# **Item 5 - Correspondence**

Thank you for the opportunity to review the Local Area Transportation Review (LATR) prepared by Gorove/ Slade Associates, Inc, dated May 9, 2022, for the (St. Angela Hall– SHA Tracking #21-AP-MO-011-xx) in Montgomery County, Maryland. The Supplemental Analysis dated November 7, 2022 was also reviewed for purposes associated with the State Highway Administration (SHA) access review. The State Highway Administration (SHA) review is complete and we are pleased to respond.

Preliminary Plan No. 120220160 A

Site Plan No. 820220220

Attachments: photos of Strathmore Avenue traffic back-ups. Photos taken late January 2022.

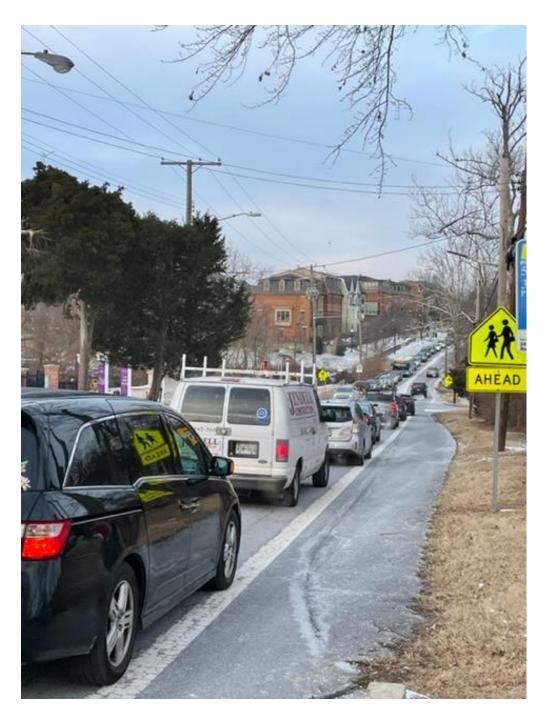
Nearside lane shows cars heading east on Strathmore Avenue, at 8 am. Picture taken at the non-signalized pedestrian crossing at Strathmore and Stillwater – this is the traffic Garrett Park Estates residents face daily, whether they attempt to walk to the Metro or exit the neighborhood via Strathmore Avenue. Cars trying to enter or exit Symphony Park and the neighborhood at the top of the picture also face great difficulty accessing Strathmore Avenue safely.

Traffic viewed from the north side of Strathmore Avenue, looking west towards Rockville Pike, 8 am. [This is where pedestrians must cross Strathmore Avenue to access the walking path to the Grosvenor/Strathmore Metro, and the Strathmore Music Center.]

View from mid-way up the block at 8 am, across from the proposed new central drive for the new development/new traffic light. Exiting from Stillwater Avenue, the entrance by the pedestrian crosswalk, is particularly difficult.

Strathmore Avenue, nearside lane looking west – photo taken Friday afternoon 3 pm. Again, exiting from Stillwater Avenue (on the right hand side) is extremely difficult, particularly for cars trying to turn left.
